Access Compliance Report

Public Rights-of-Way

(Curb Ramps)

Intersection ID: N/A	Main Street: E_4TH_ST	Cross Street: S_DAVIDSON_ST	Location: S
ADA ID: 86679E58E4DA	Ramp Type: PerpDiag	Initial Pass/Fail: Fail	Overall Compliance: No
Severity Score: 13.75			
Codes/Mitigation Info/Possible Solution		Field Measurements/Component Compliance

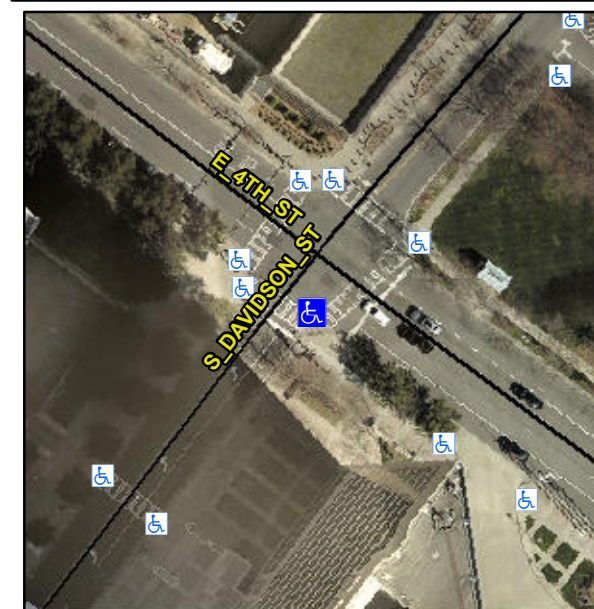
Not Found, R304.2.2, R304.5.3

Compliance	Description	Data	Compliance	Description	Data
N/A	Ramp Length (in)	62.0	No	Ramp Slope (%)	9.5
Yes	Ramp Width (in)	135.0	No	Ramp XSlope (%)	2.8
N/A	Flare Type LT	N/A	N/A	Flare Type RT	N/A
N/A	Flare Slope LT (%)	N/A	N/A	Flare Slope RT (%)	N/A
N/A	Flare Traversable LT?	N/A	N/A	Flare Traversable RT?	N/A
N/A	Landing Length (in)	N/A	N/A	DWS Provided?	N/A
N/A	Landing Width (in)	N/A	N/A	DWS Contrast?	N/A
N/A	Landing Slope (%)	N/A	N/A	DWS Length (in)	N/A
N/A	Landing X Slope (%)	N/A	N/A	DWS Full Width?	N/A
N/A	Landing Curb? (Y/N)	N/A	N/A	DWS Offset (in)	N/A
N/A	Shared Landing?	N/A			
N/A	Gutter Ponding?	N/A	N/A	Gutter Slope (%)	N/A
N/A	Gutter Lip Ht (in)	N/A	N/A	Gutter X Slope (%)	N/A
N/A	Painted X Walk1?	Yes	N/A	Painted X Walk2?	Yes
	X Walk 1 Direction	To NE		X Walk 2 Direction	To NW
N/A	X Walk 1 Width (in)	106.0	N/A	X Walk 2 Width (in)	111.0
	X Walk 1 Slope (%)	8.4		X Walk 2 Slope (%)	3.4
	X Walk 1 X Slope (%)	1.4		X Walk 2 X Slope (%)	4.4

Remove & Replace Curb Ramp With Two New Directional Ramps or Equivalent.
